CITY OF WEST TORRENS

# Notice of Panel Meeting

### 6.2.1 239, 241-243 Richmond Road, RICHMOND

Application No 21028599

DWG REF **DA 2A**

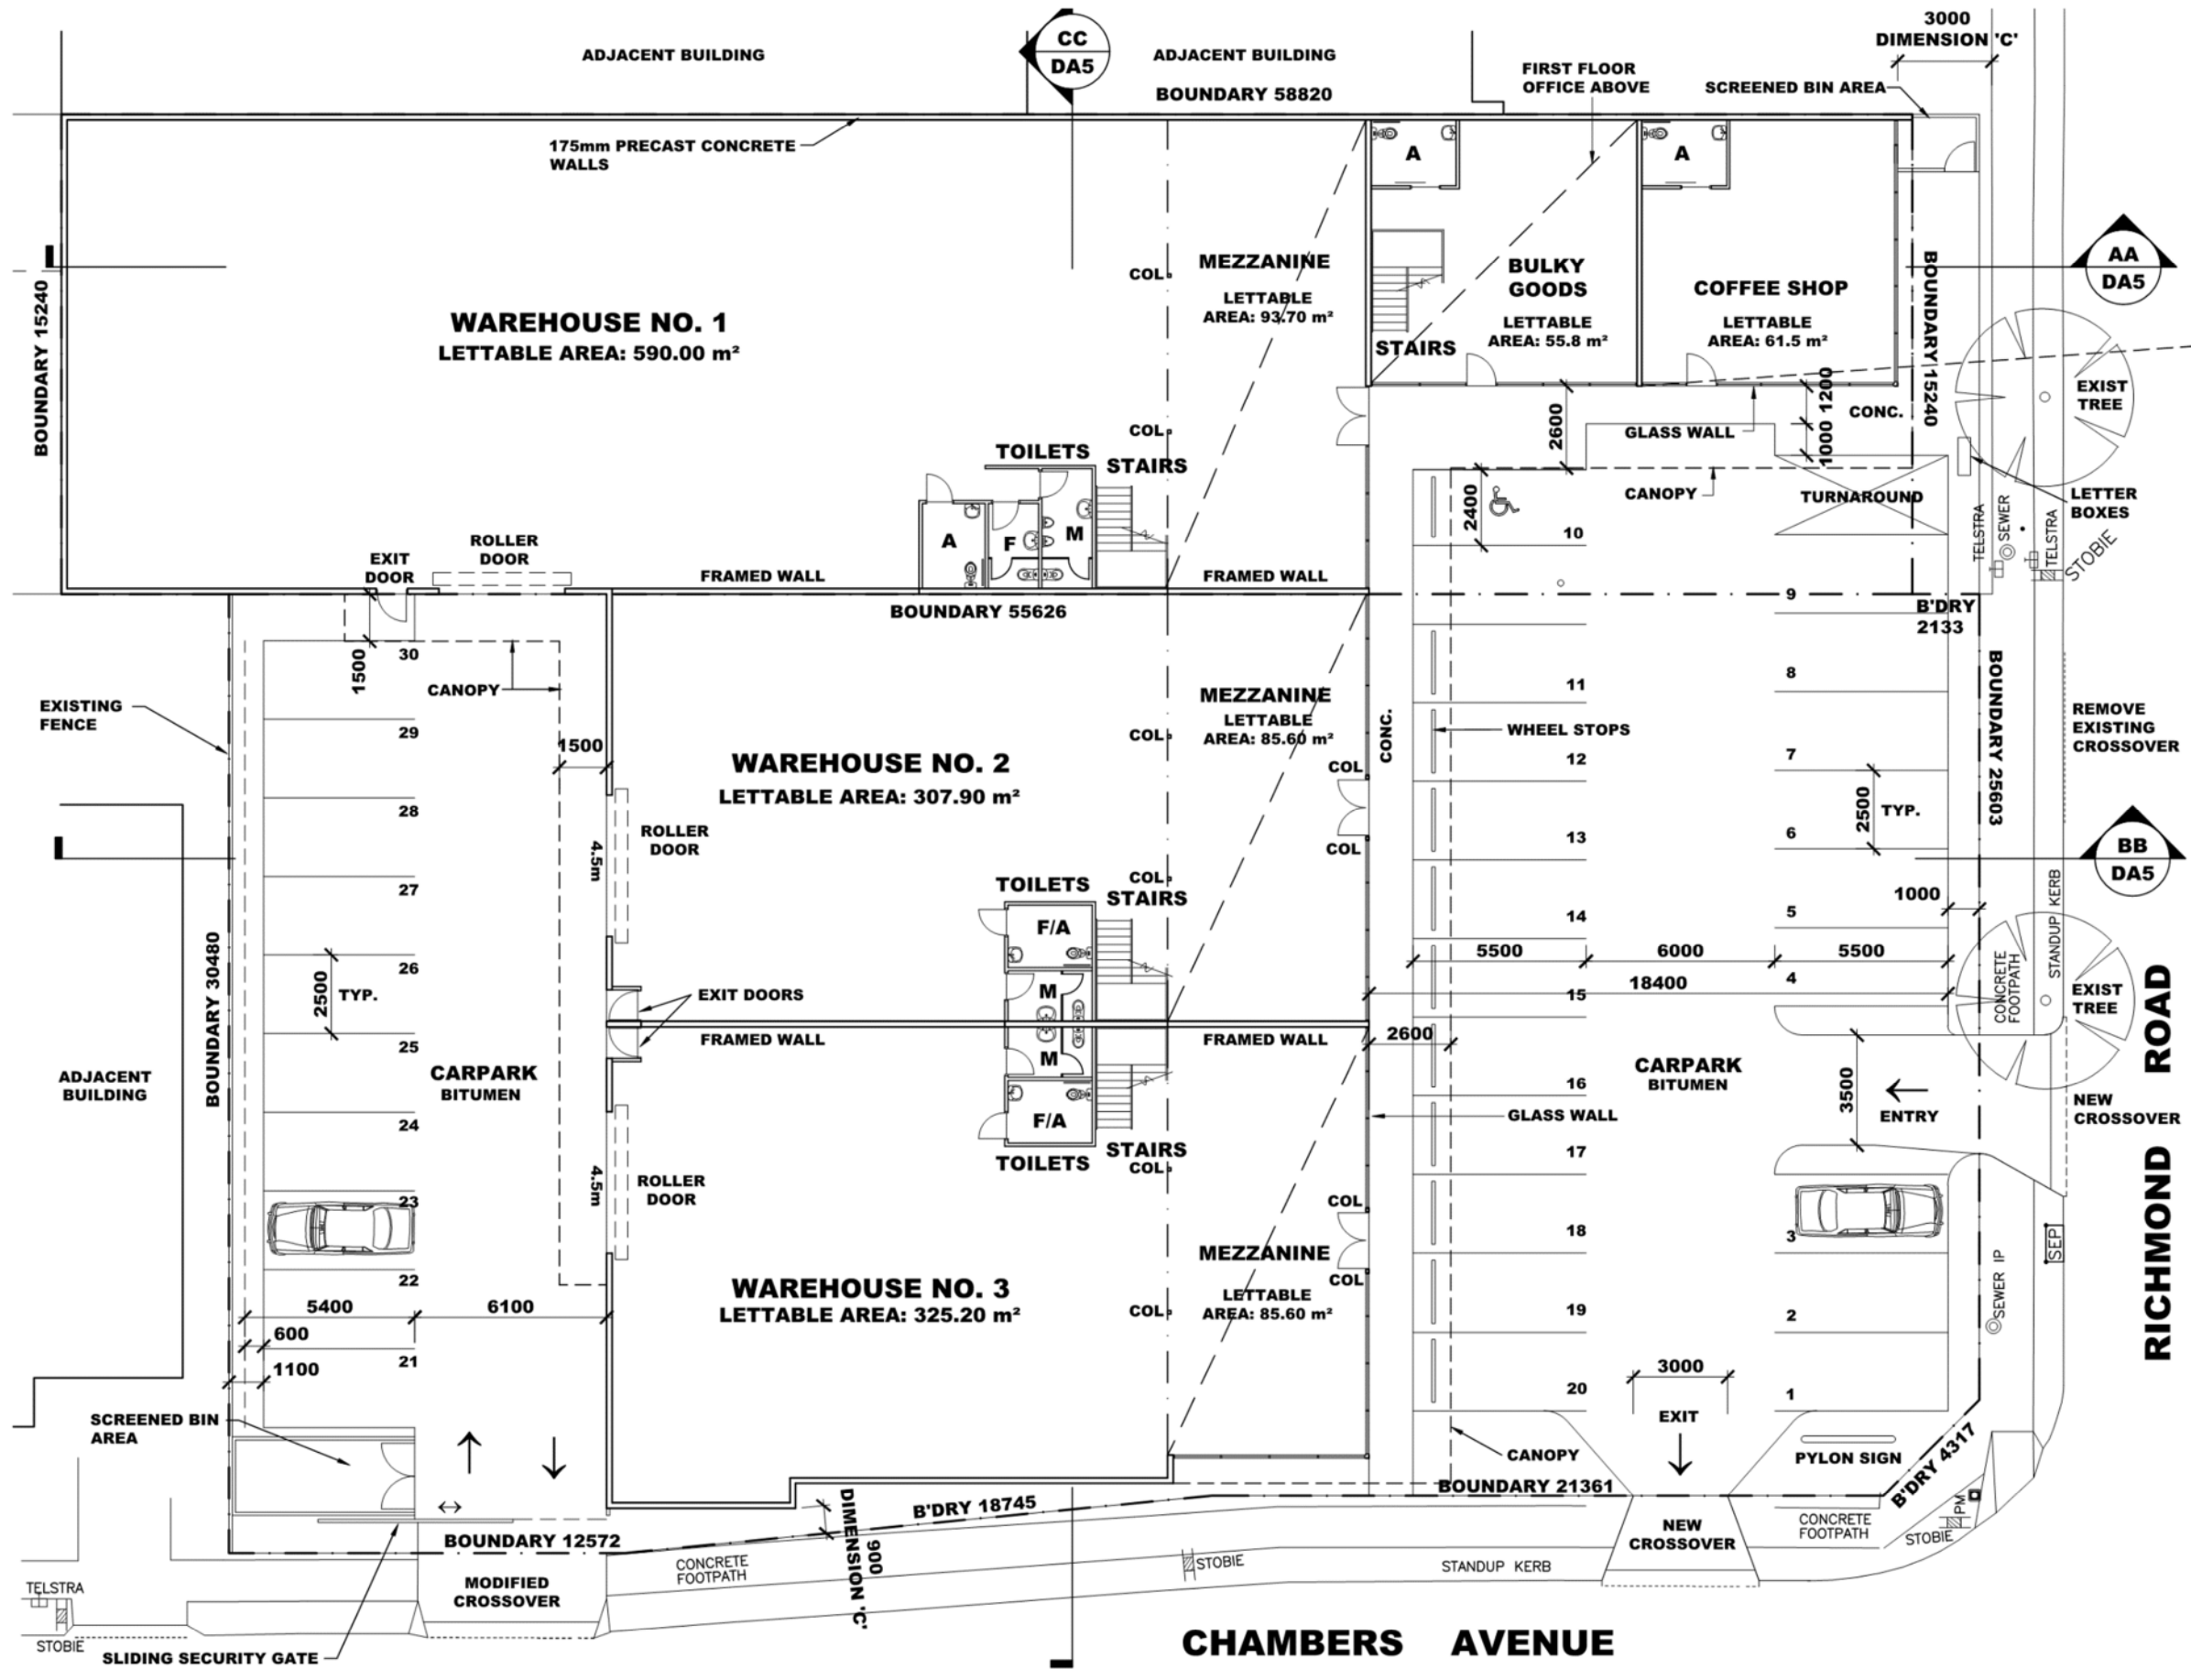
separation from the adjacent junctions. The Chambers Avenue access is located in close proximity to the Richmond Road/Chambers Avenue junction and is non-compliant with Figure 3.1 in AS/NZS2890.1:2004.

With respect to the Chambers Avenue access to the Richmond Road car park, it is recommended that this be located slightly further away from the junction to achieve the objective of Figure 3.1 of AS/NZS2890.1:2004 and made two-way to improve the operation of the car park. This arrangement will avoid the potential for vehicles approaching from the east to enter the site via the egress or being required to undertake a combined u-turn and left turn manoeuvre to access the site. It is understood that this will require modification to the car parking adjacent to Chambers Avenue.

9. An amended plan shall be provided to Council prior to the issue of Development Approval showing vehicular access via Richmond Road limited to an ingress only access in reference to plan DA 2A dated March 2022, the access point angled at 70 degrees to the road and suitably signed and linemarked to reinforce the desired traffic flow.
10. All vehicles shall enter and exit the site in a forward direction and all vehicle manoeuvring areas shall be kept clear of impediments to manoeuvring.
11. The redundant crossover on Richmond Road shall be closed and reinstated to Council's kerb and gutter standards at the applicant's expense.
12. Stormwater run-off shall be collected on-site and discharged without impacting the safety and integrity of the adjacent road network. Any alterations to the road drainage infrastructure required to facilitate this shall be at the applicant's cost.

1. Vehicular access to serve the site via Richmond Road shall be limited to an ingress only access located in accordance with the Site Plan by Olympic Developments, reference DA 2A, dated March 2022. The access point shall be angled at 70 degrees to the road and suitably signed and line-marked to reinforce the desired traffic flow.
2. All vehicles shall enter and exit the site in a forward direction and all vehicle manoeuvring areas shall be kept clear of impediments to manoeuvring.
3. The redundant crossover on Richmond Road shall be closed and reinstated to Council's kerb and gutter standards at the applicant's expense.
4. Stormwater run-off shall be collected on-site and discharged without impacting the safety and integrity of the adjacent road network. Any alterations to the road drainage infrastructure required to facilitate this shall be at the applicant's cost.

**Figure 2 Access Prohibited Zones**

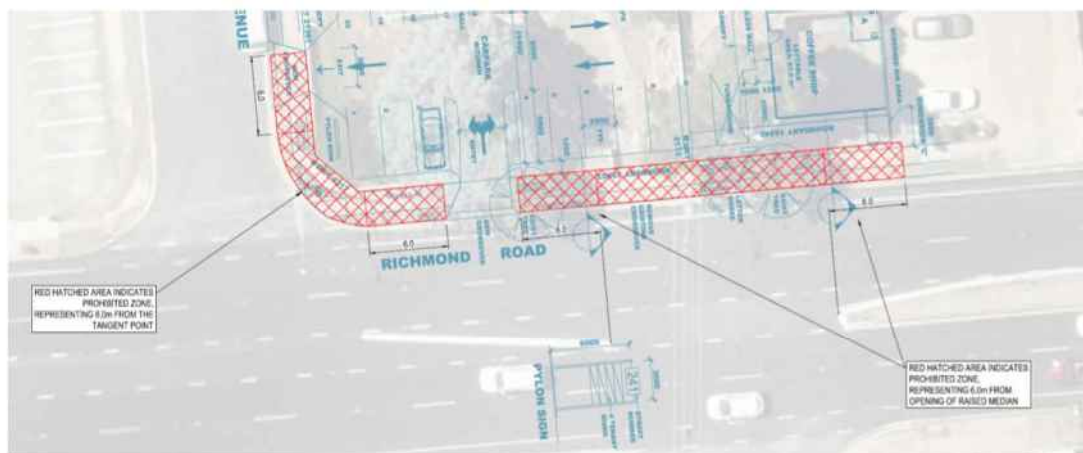
The proposed development will have an access point on Richmond Road and two access points on Chambers Street. The Richmond Road access point has been identified by DIT as not meeting the requirements of Major Transport Routes Overlay DTS/DPF 4.1 – Access – Location (Spacing) – New Access Points. A review of the site with regards to the requirements of the P&D Code has found there is limited opportunity for an access point on Richmond Road.

In order to comply with the P&D Code, it is proposed that an entry only driveway be provided on Richmond Road, and an exit only to Chambers Avenue. This arrangement will provide safe and convenient access given the small size of the car park and low traffic volumes estimated for the site. It will ensure that the existing junction of Aldridge Terrace will not be impacted by the proposed development.

### 3.1 Parking Layout

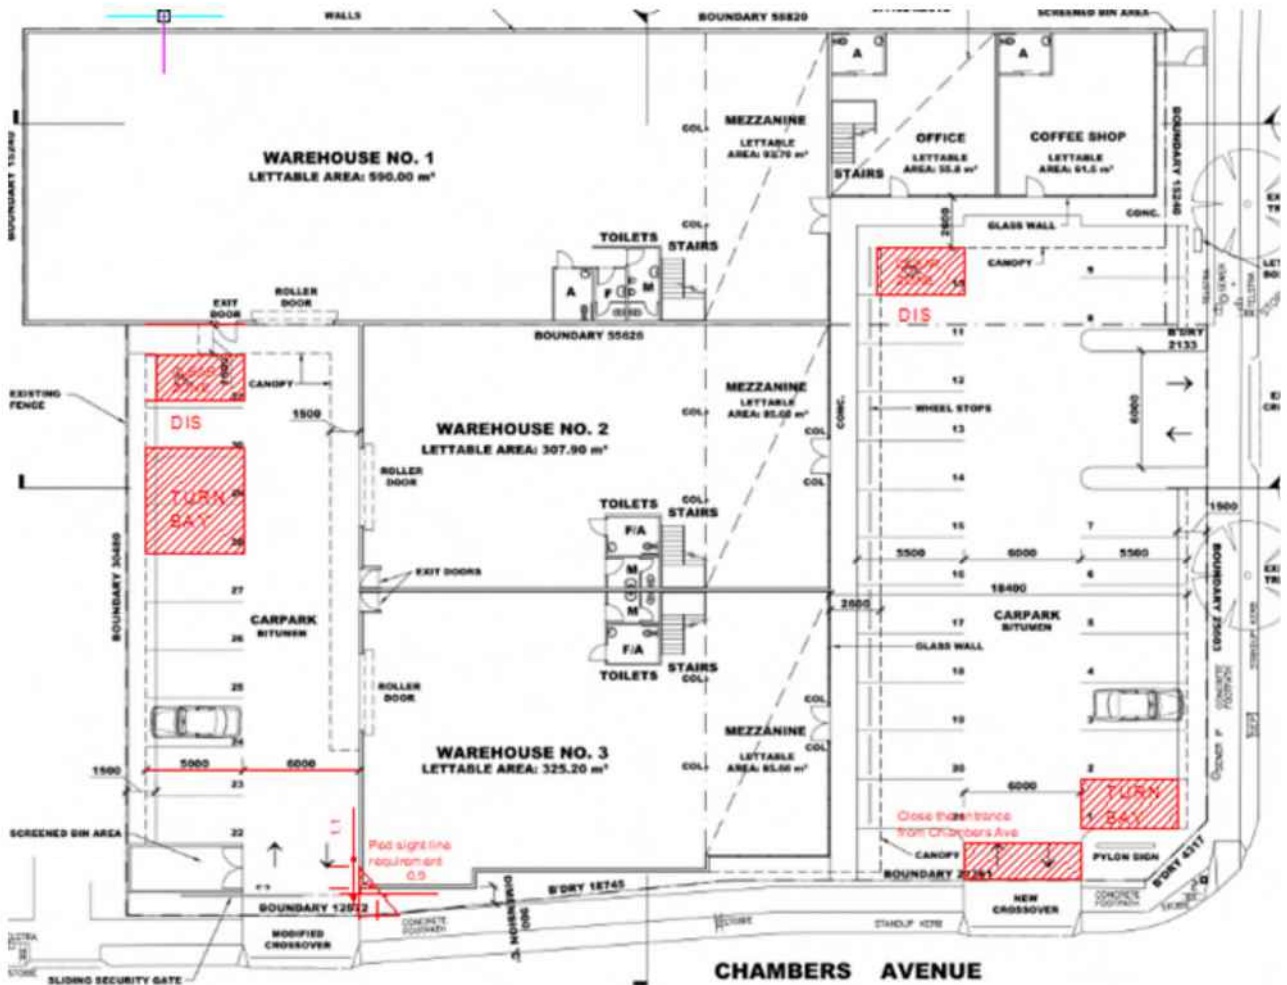
There are a number of amendments required to the parking layout to enable the layout to meet the requirements of the current parking standards and also to deal with the servicing aspects of the proposal.

I note that there is limited information provided regarding service vehicles that may require access to the warehouses other than the comment that the warehouses would be 'used by occupiers who do not require large vehicle access to the warehouse facilities' (see Rod Roach Architecture Report August 2021 Page 2). Given the constrained nature of the rear car park (Chambers Avenue) where the roller doors of the warehouses are located, my assessment indicates that the 6.4m long SRV truck (as per AS 2890.2-2018) would be able to access the warehouses and rear car parking layout. Vehicles larger than the SRV would not be able to access the roller doors. A condition restricting service vehicles to SRV size for the proposed 3 warehouses would be appropriate.

- vehicles queued to exit Chambers Avenue to Richmond Road. The proposed access point should be deleted. One parking space would be lost as a result (to provide a turnaround bay for the dead end car park).
3. While the proposed car park access point in Richmond Road would be located opposite Aldridge Road, it would be possible to provide a 'seagull' type island at the median opening to restrict right turns into and out of the subject site in Richmond Road. I leave it to DIT to specify its requirement for the central median arrangement as Richmond Road is managed and controlled by DIT.
  4. To encourage cycling as a mode of transport, I recommend that 2 bicycle rails be provided at the front car park.
